WATER QUALITY MEMORANDUM

Utah Coal Regulatory Program

RE: Second Quarter 2017 Water Monitoring, Genwal Resources, Inc., Crandall Canyon Mine, C/015/0032 Task ID #5528

Below is a graph of the pre-treatment (PRE-002) total iron concentration shown as a monthly median since January 2010.

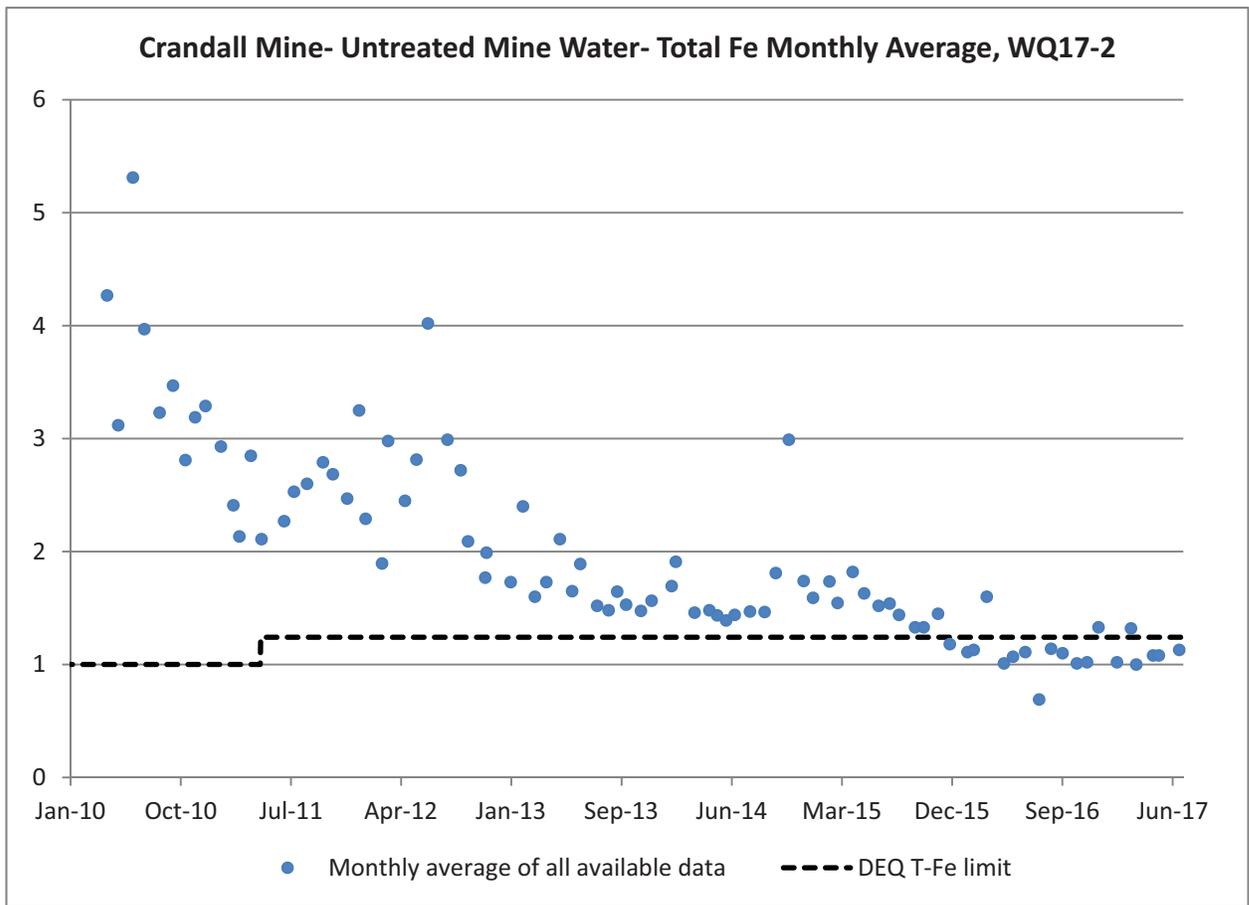
The total iron concentrations in the pre-treatment mine water for quarter 2016 remained under the 1.24 mg/L UPDES limit. The three sampling events for this quarter in April, May, and June yielded total iron concentrations of 1.08, 1.08, and 1.13 mg/L, respectively.

Historic trends in total iron show decreasing concentrations between January 2010 and June 2014. In Fall 2014, total iron became increasingly variable with concentrations slightly increasing in pre-treatment mine discharge. However, beginning in early 2015, concentrations have become stable, and total iron exhibits an overall decreasing trend.
